Memorandum

RE: **Mobil Mart at Baxter and Clayton (Brite Worx)**: A Site Development Plan, Landscape Plan, Lighting Plan, Architectural Elevations and Architect's Statement of Design for a 1.72 acre tract of land zoned "PC" Planned Commercial District located on the western corner of the intersection of Clayton Road and Baxter Road.

Subject: Brite Worx (Wallis Companies) Site Development Plan
14905 Clayton Road
Chesterfield, MO 63017
CEC Project #153-224

Planning Commission Staff Report

Figure 2: Buttonhook Screening Wall Location

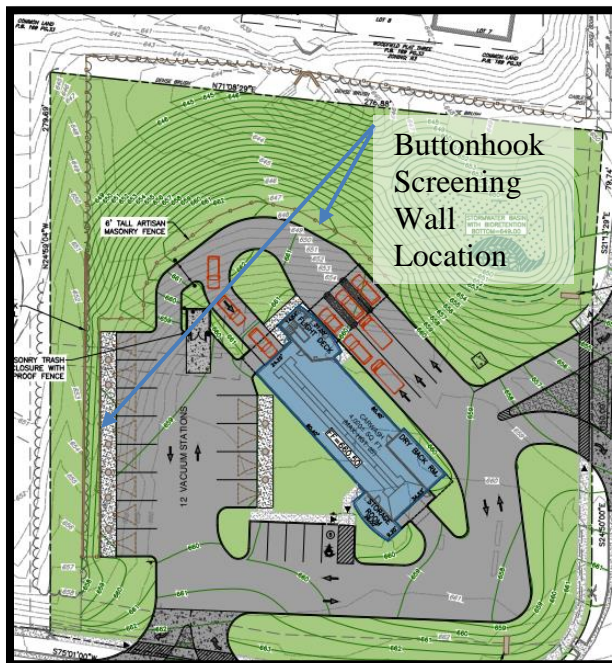
The Site Development Plan was reviewed at the July 9, 2018 Planning Commission meeting. At that time, there was discussion regarding the height of the screening wall around the buttonhook, as shown in Figure 2. The Commission requested to see section views of the site. The applicant has provided section views with sight lines that include both a 6' fence, as required by the site specific ordinance, and a taller 8' fence as requested by the Planning Commission.

The Site Development Plans still reflect a 6' wall. If the Planning Commission recommends approval with an 8' wall, the plans will be revised prior to the Planning and Public Works Committee Meeting.

EXHIBIT A

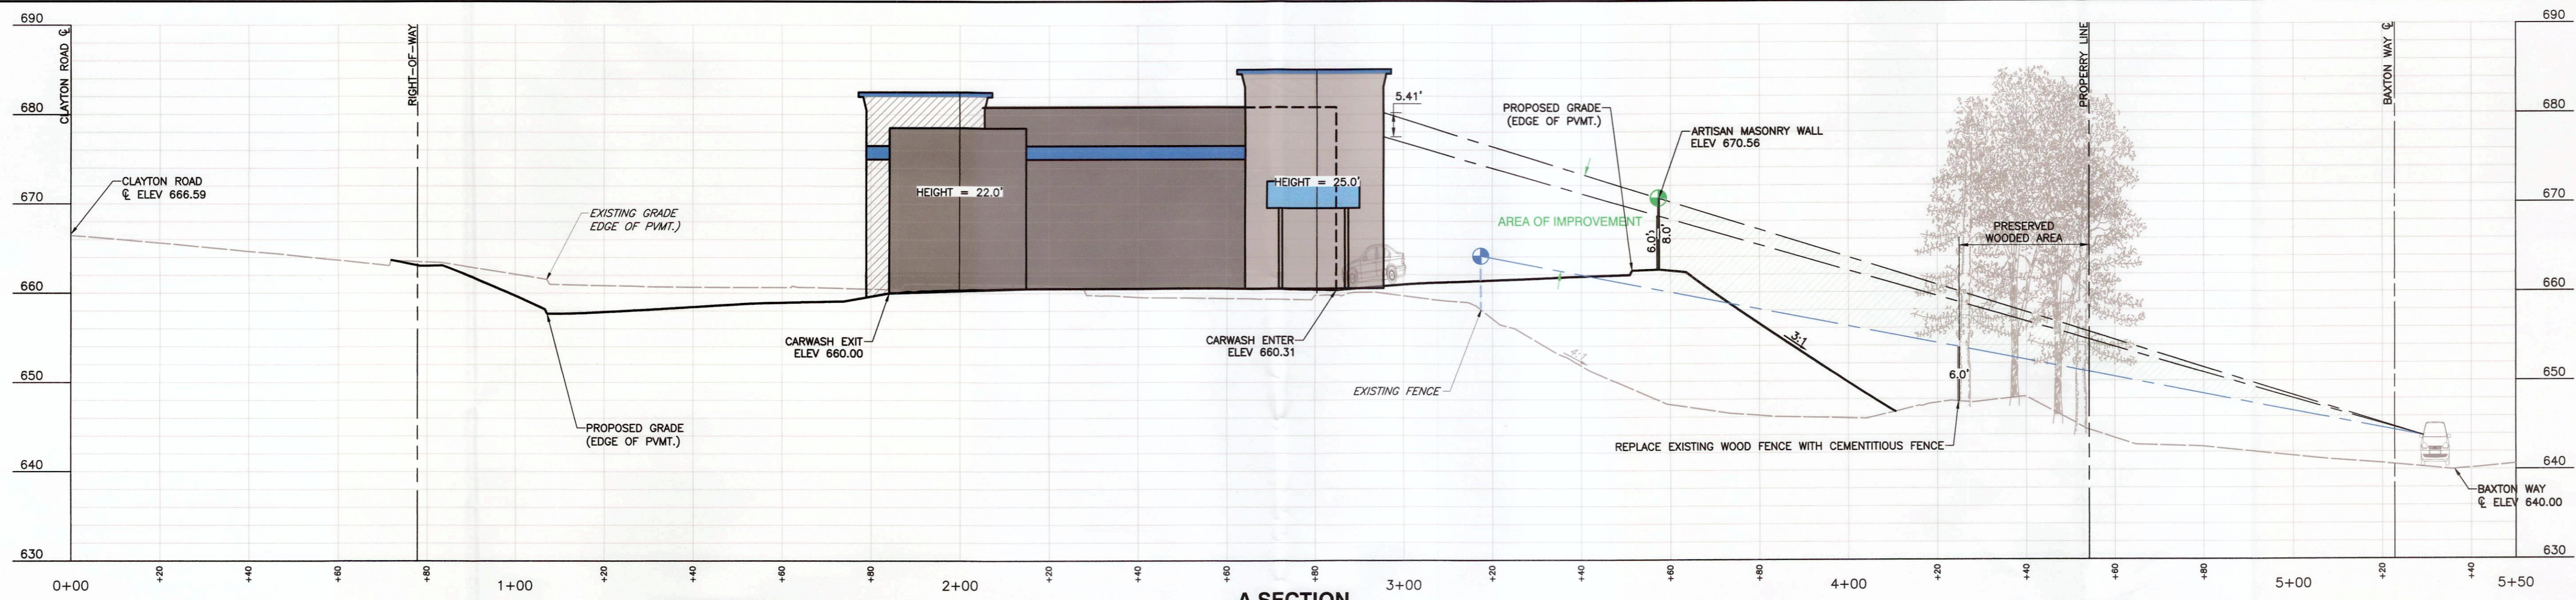
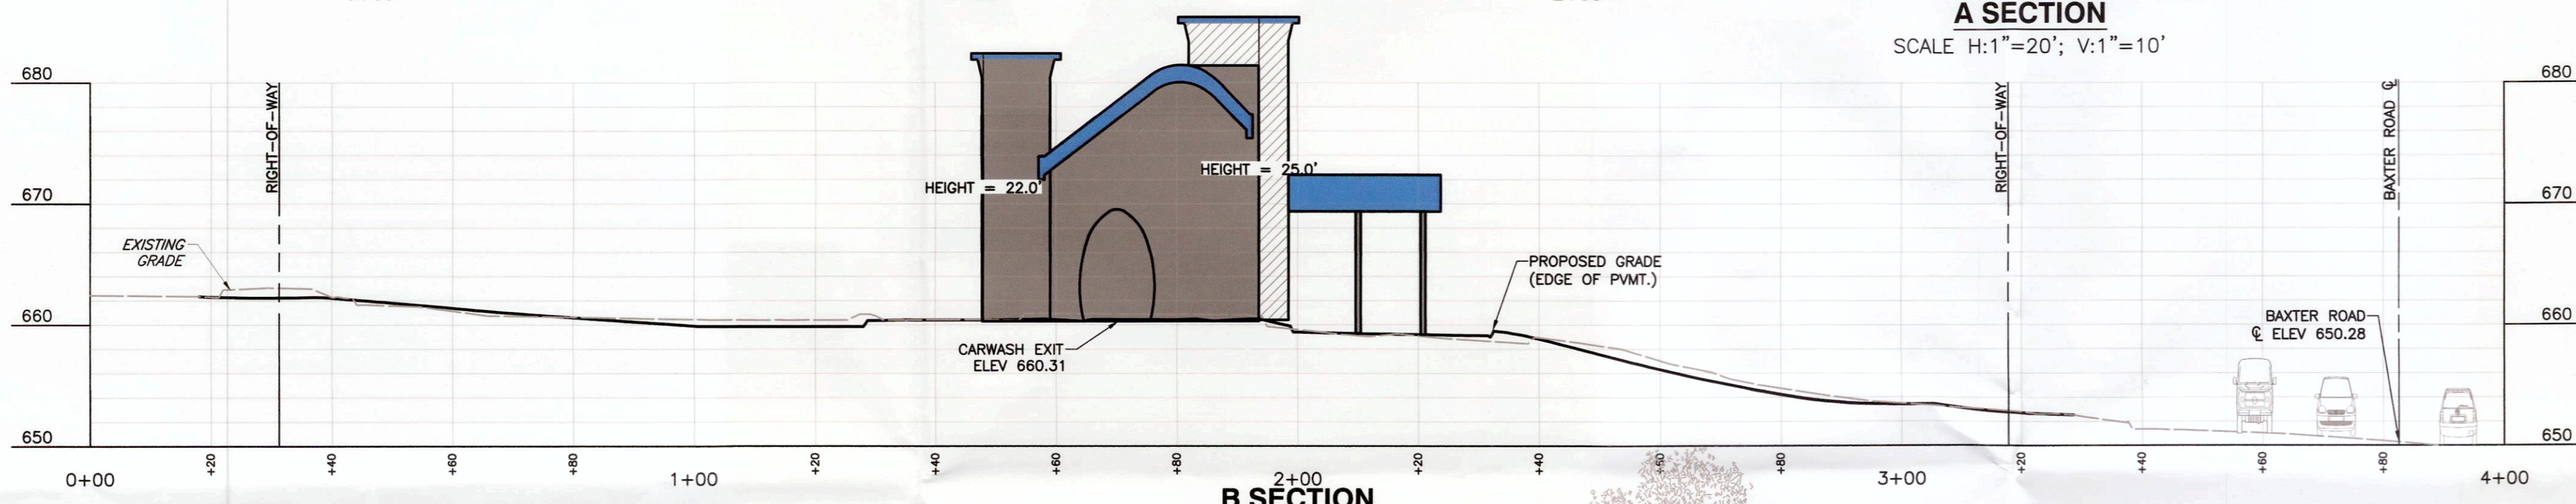
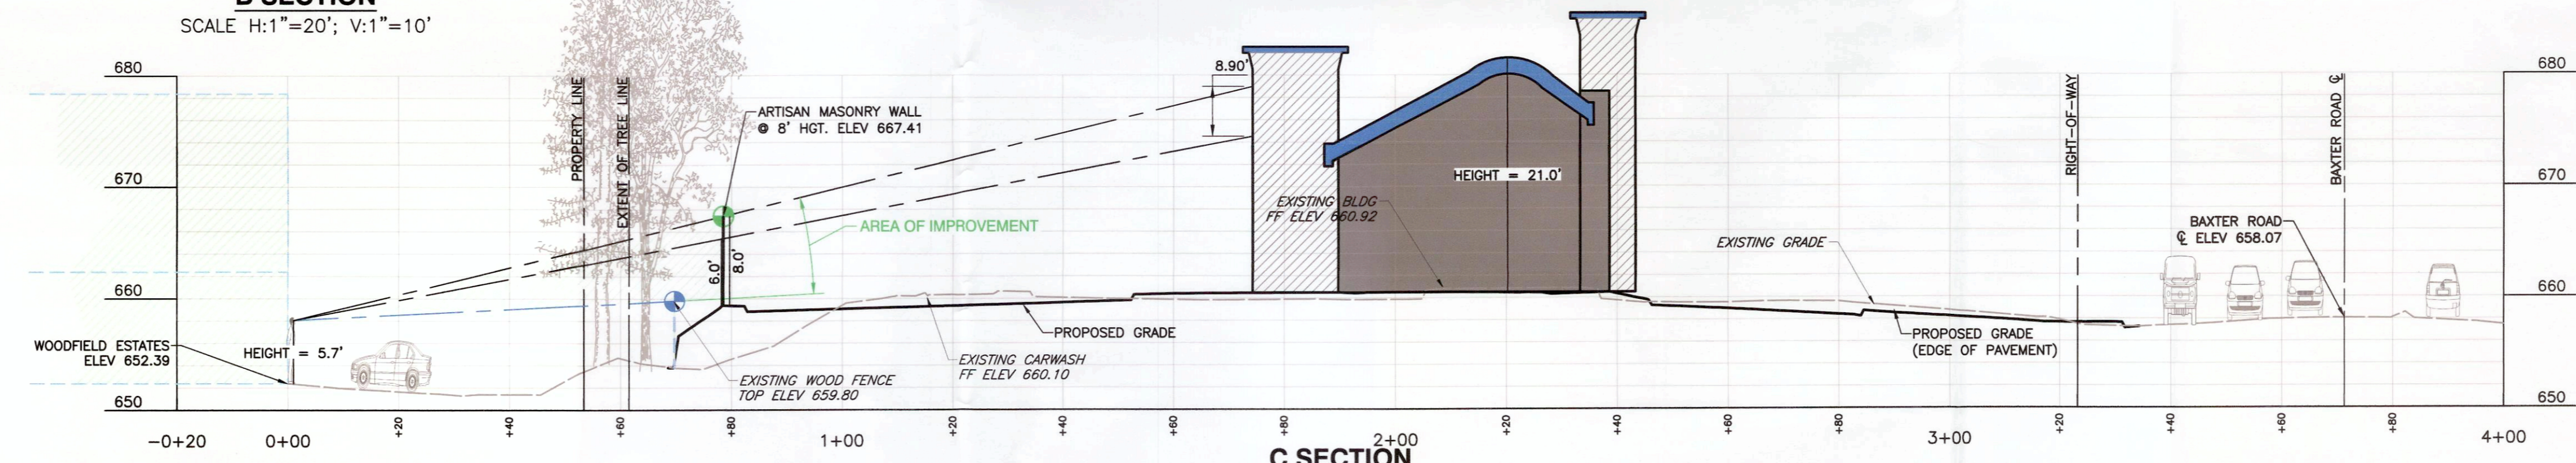
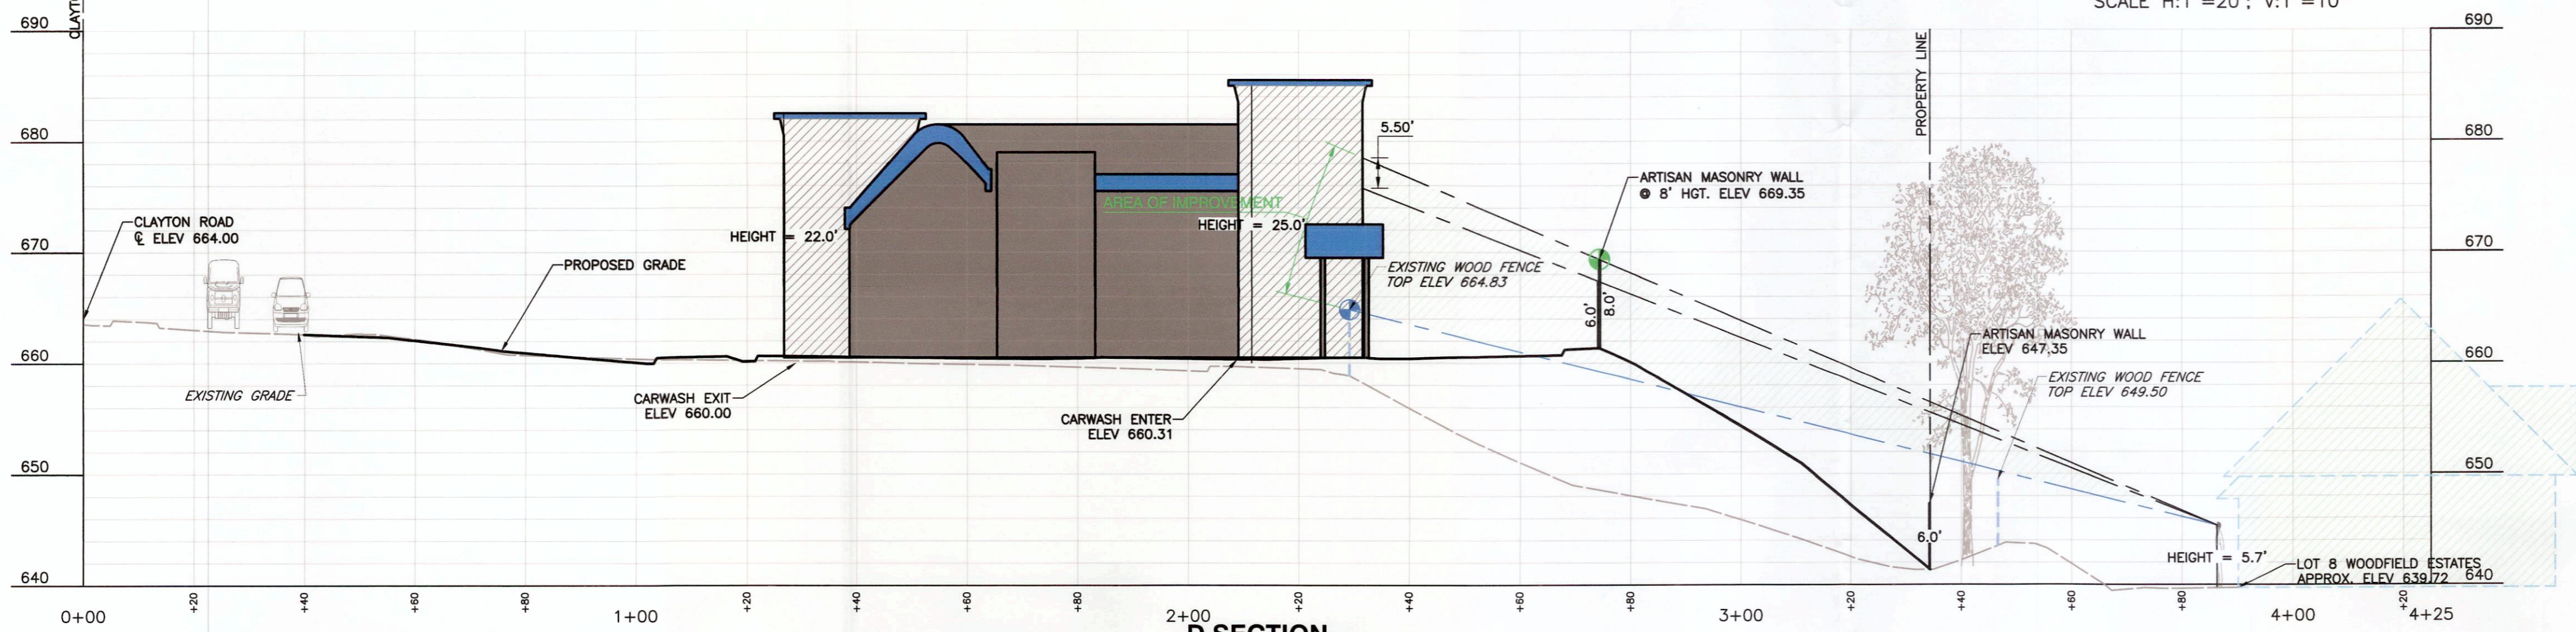
Planning Commission reviewed the project at the July 9, 2018 meeting, where additional information regarding the colors of the accessory elements and revised section views were requested. No vote was held at that meeting. At the July 23, 2018 meeting, Planning Commission recommended approval of the request by a vote of 6 – 1 with the conditions of constructing the proposed six-foot wall and utilizing silver accents on the vacuum stations in place of the proposed blue. Ordinance 2977 has automatic Power of Review for the Site Development Plan, Landscape Plan, Lighting Plan, Tree Preservation Plan, and Architectural Elevations.

Umbrella Arch Plan

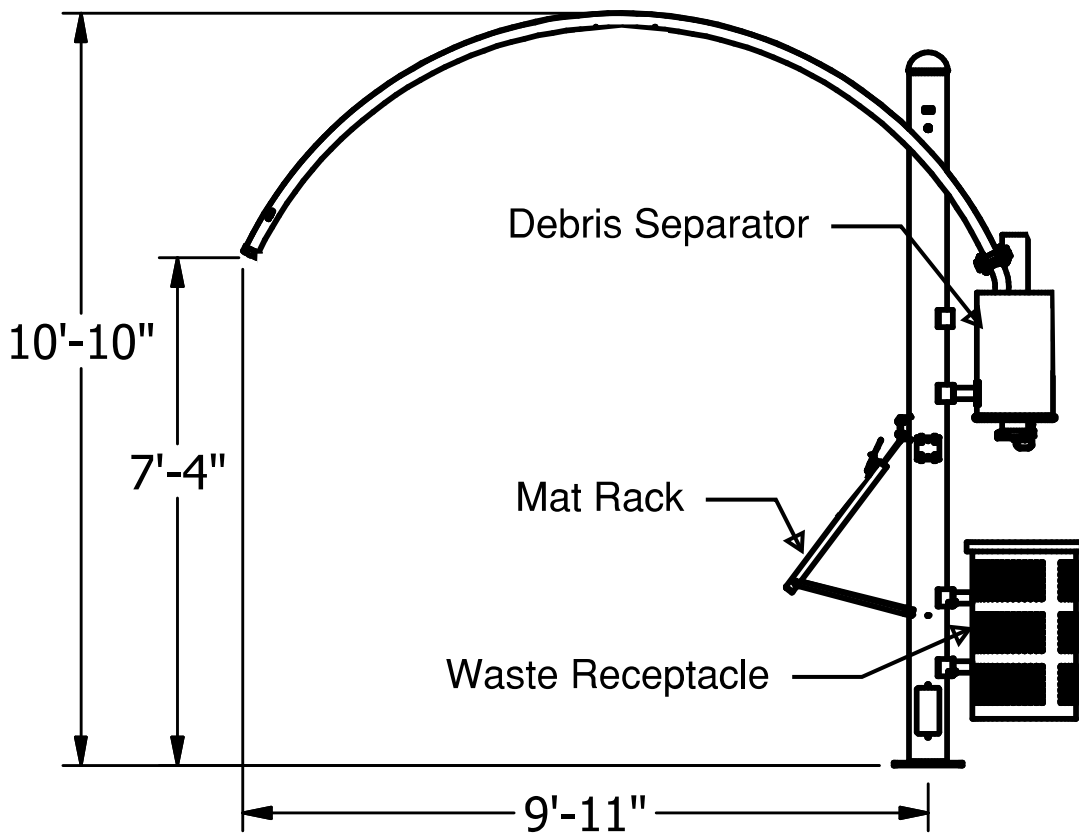
There was also considerable discussion regarding the accessory structures such as the vacuum balls and sun shades. The discussion resulted in a request that the applicant provide additional colors for these elements.

TYPE: PROPOSE 'UMBRELLA' ARCH (PHOTO ON THE LEFT) WITH POWDER COATED POSTS, ARCHES, AND OPTIONS IN BLUE *SIMILAR* TO THE PHOTO ON LEFT *BUT* USING THE SAME COLOR AS THE BLUE ACCENT ON THE BLDG.

- IN THE LEFT PHOTO, WE ARE PROPOSING TO SWAP ALL THE YELLOW FEATURES WITH THE BUILDING'S BLUE ACCENT COLOR BUT *WITHOUT* A CANOPY CLOTH
- THE PHOTO ON RIGHT SHOWS THE 'PALM' ARCH, NOT THE 'UMBRELLA' ARCH WE ARE PROPOSING, BUT SHOWS THE STATIONS W/O A CANOPY CLOTH USING *SIMILAR* COLORS *EXCEPT* WE ARE PROPOSING *ALL* BLUE (IN LIEU OF BLUE CANOPY CLOTH).

In response the applicant has submitted a different vacuum station that eliminates the ball element and the shade structure element. The new proposed vacuum stations will be placed on the stripe lines of the parking spaces and be 10' tall. The applicant is requesting the poles be blue. They have provided photos of the new vacuum station design. These are included with this report.
